Project # PR-2022-007219,  
SI-2022-01478, VA-2022-00235  
Major Amendment to allow for a  
new multi-family development  
and a Variance - EPC to the  
required Landscape Buffer. EPC  
Approval September 15, 2022

<b>MONTGOMERY/ WYOMING APARTMENTS</b> <b>SITE PLAN</b>	DRAWN BY RMG DATE 02/15/2023 2022030_SITE PLAN 02.15.23
	 5571 MIDWAY PARK PLACE NE ALBUQUERQUE, NM 87109 (505) 858-3100 www.tierrowestllc.com	SHEET # <b>SP-1</b> JOB # 2022030

**RE: Titan - WFH  
Conceptual Grading & Drainage Plan  
Engineer's Stamp Date: 04/18/23  
Los Pastores Master Drainage Plan Amendment Report  
Engineer's Stamp Date: 04/01/23  
Hydrology File: F19D013D**

**Project # PR-2022-007219**  
SI-2022-01478– Site Plan – Major Amendment  
VA-2022-00235-Variance- EPC

SHEET CONTENTS:  
 DUMPSTER  
 SHEET NO.  
**A9.03**  
 22135

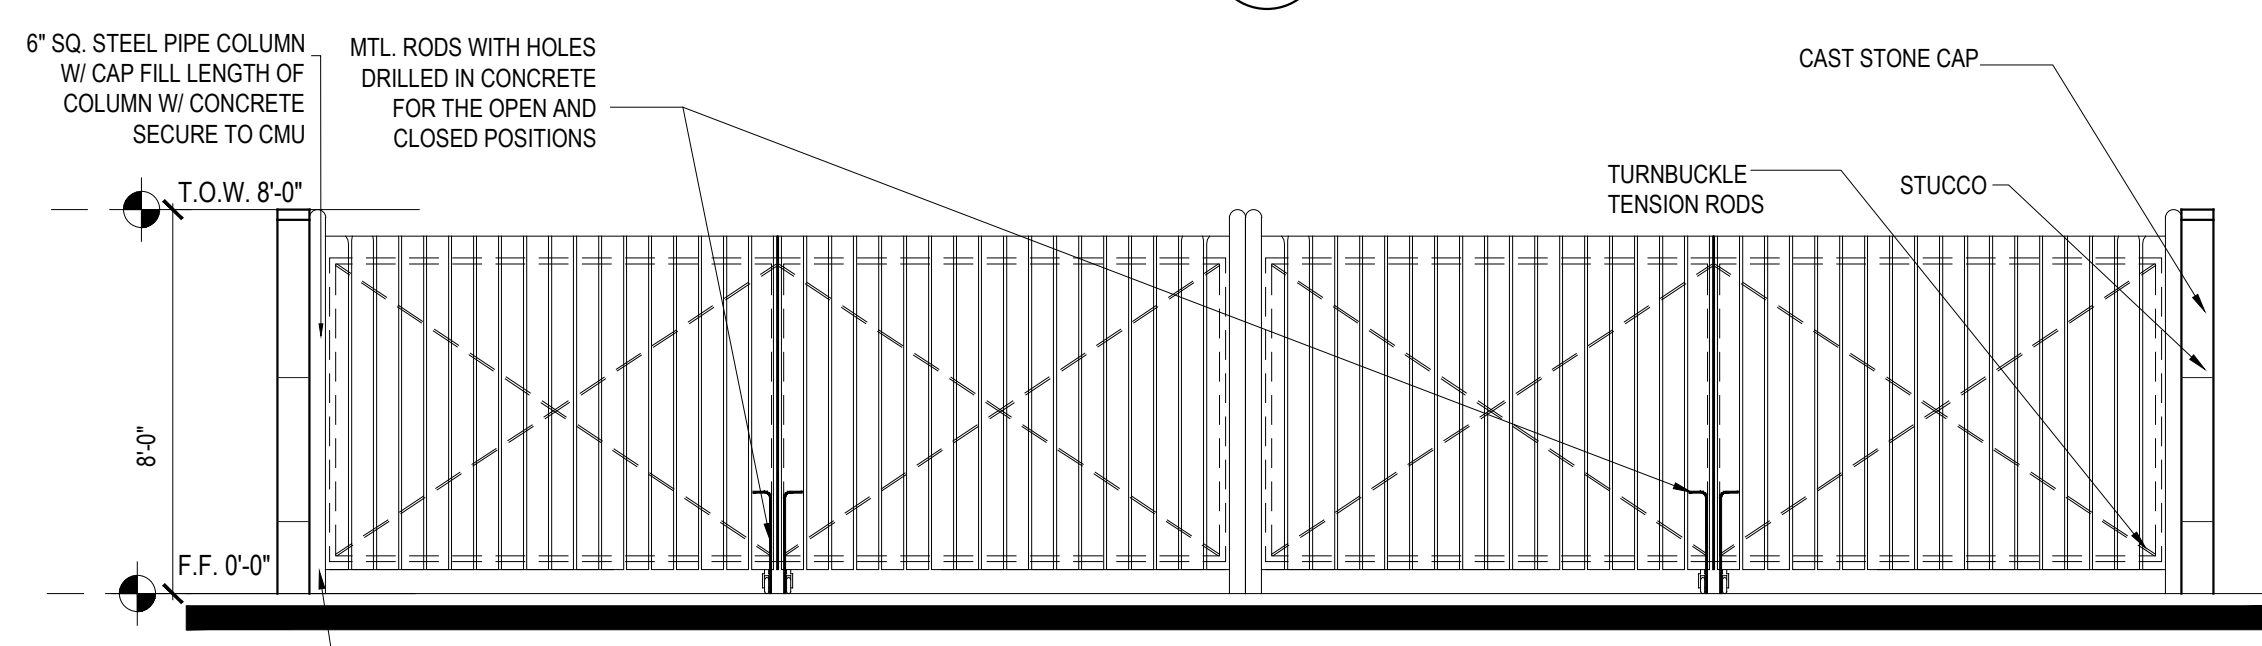
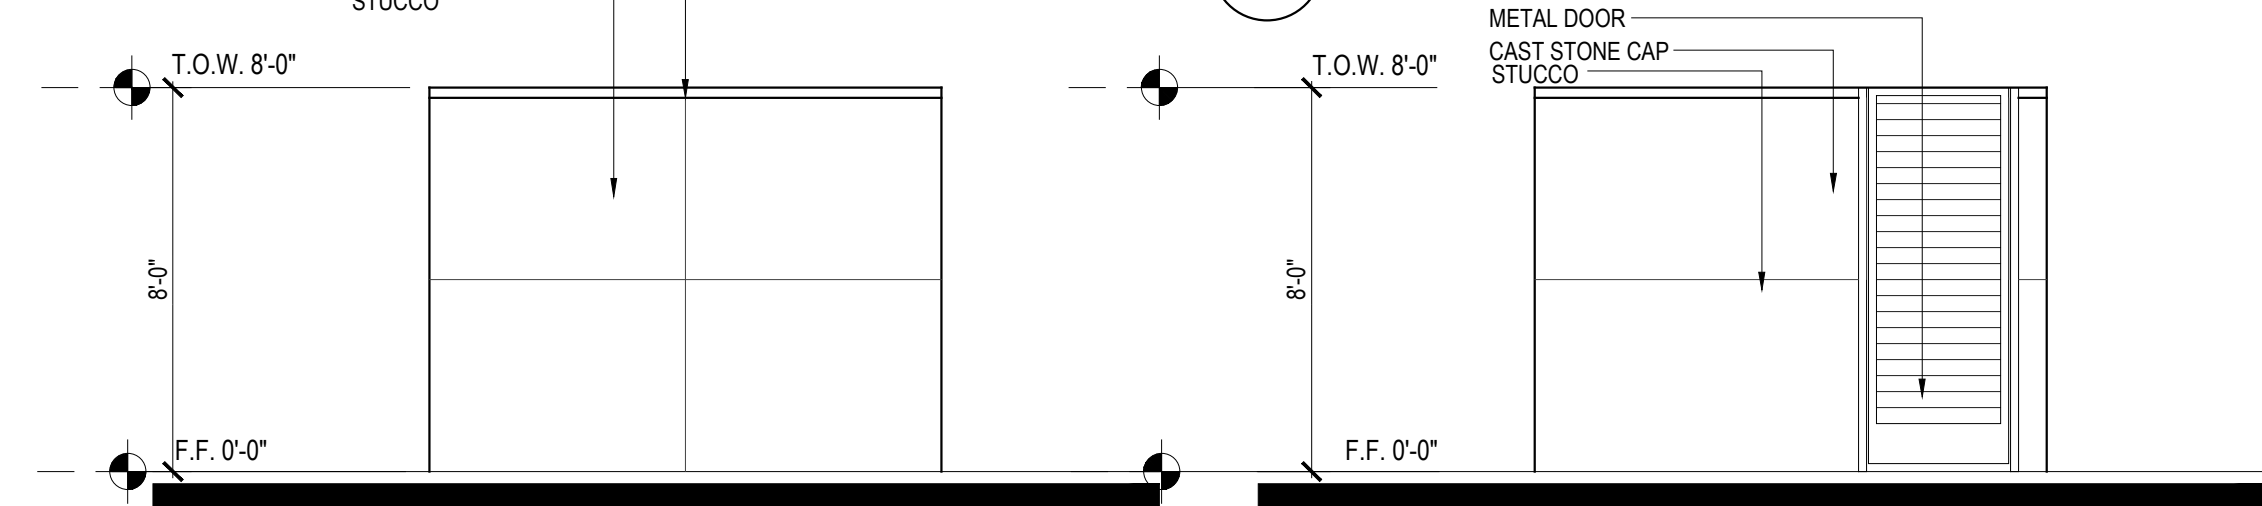
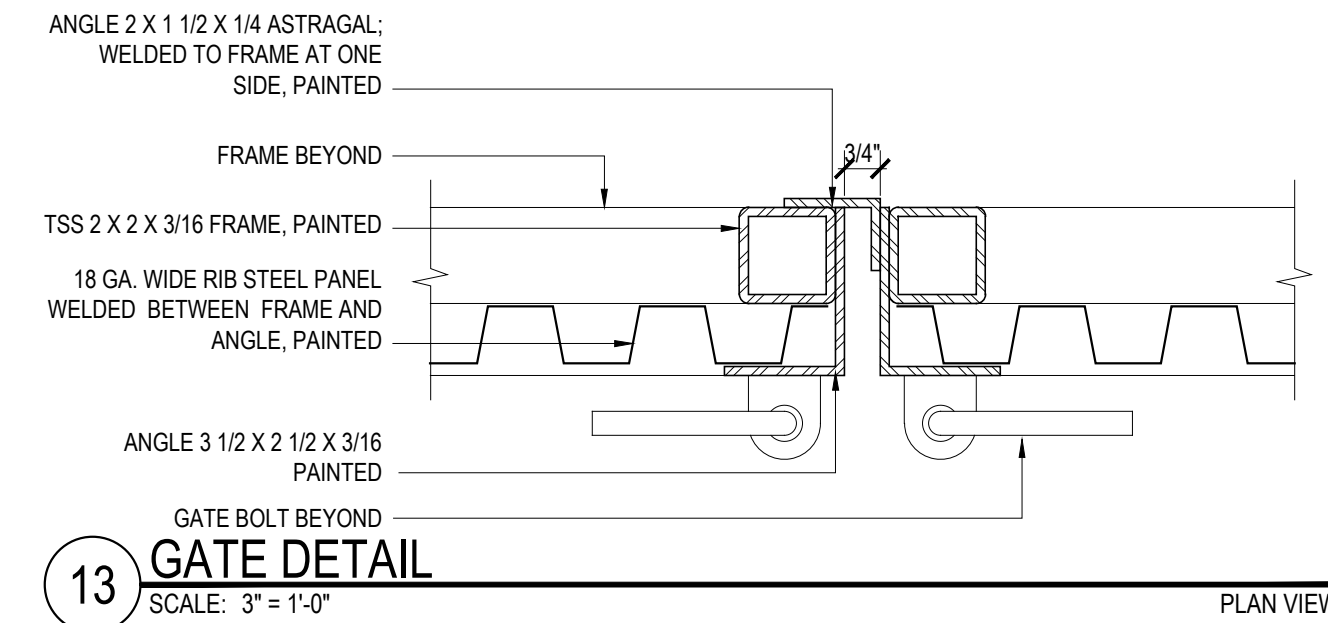
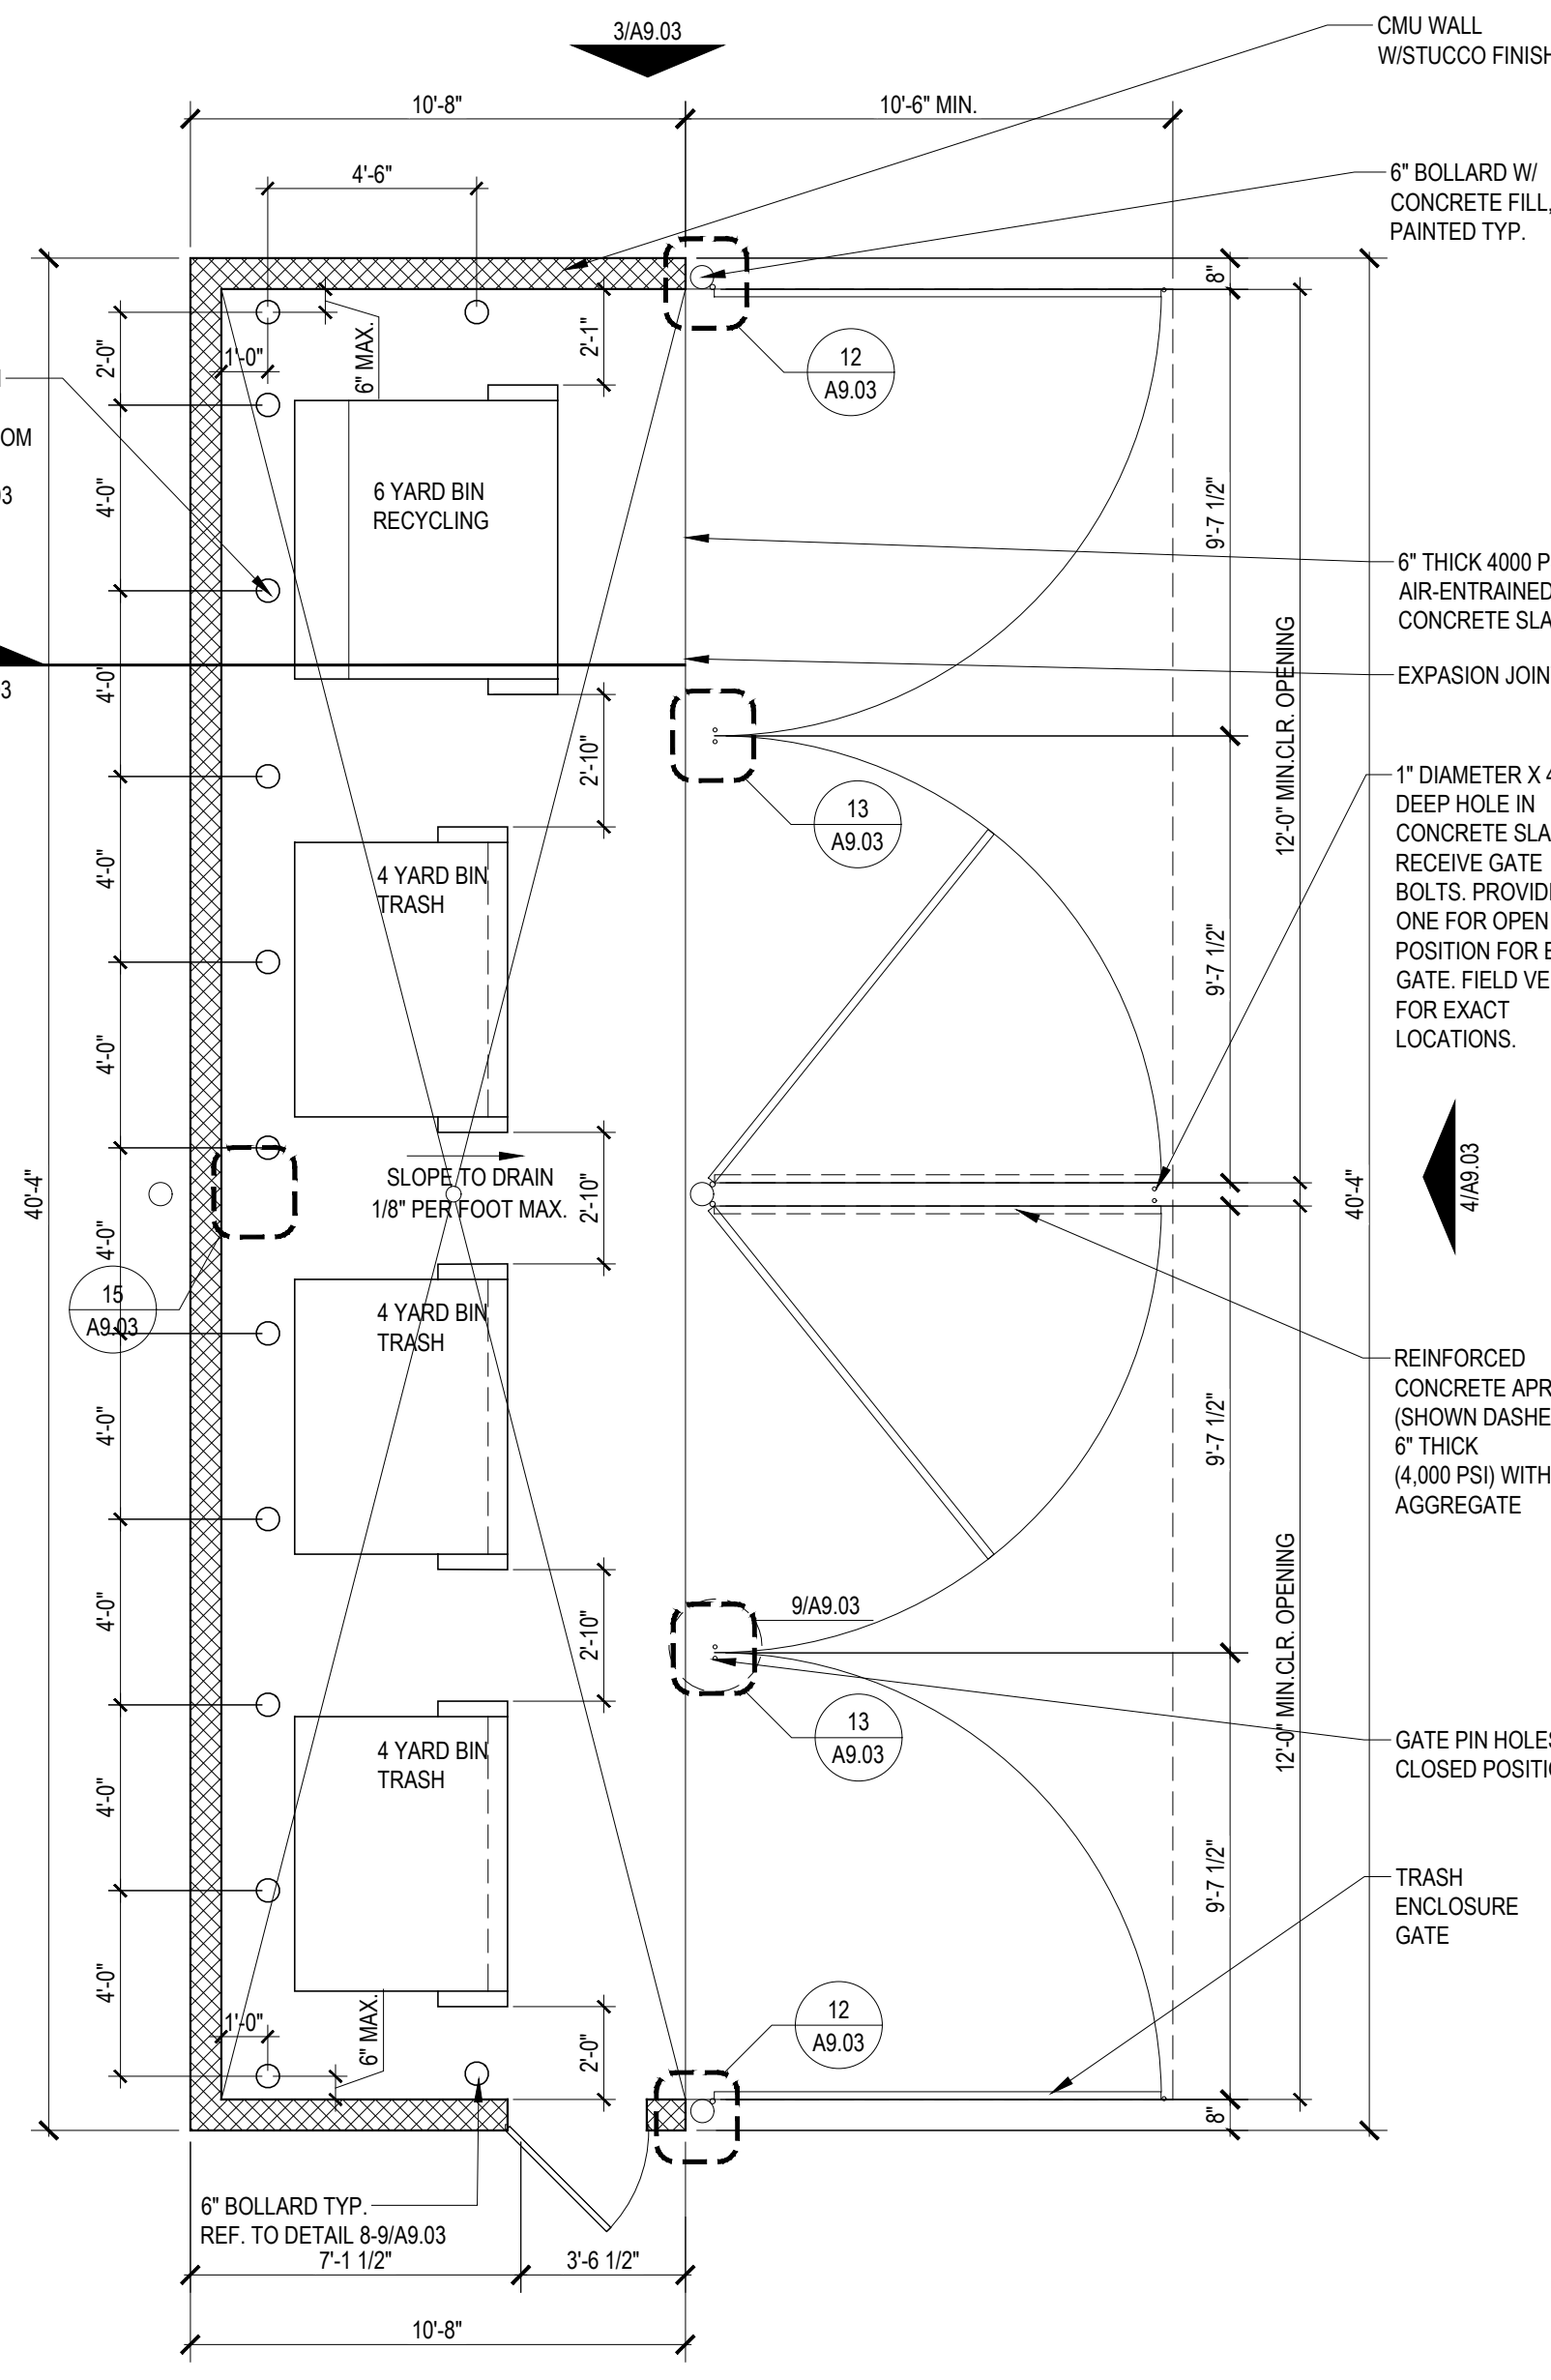
B. A site plan approved for access by the Solid Waste Department will be required.

*Agreed, detail sheet A9.03 depicts the trash enclosure at 8 feet.*
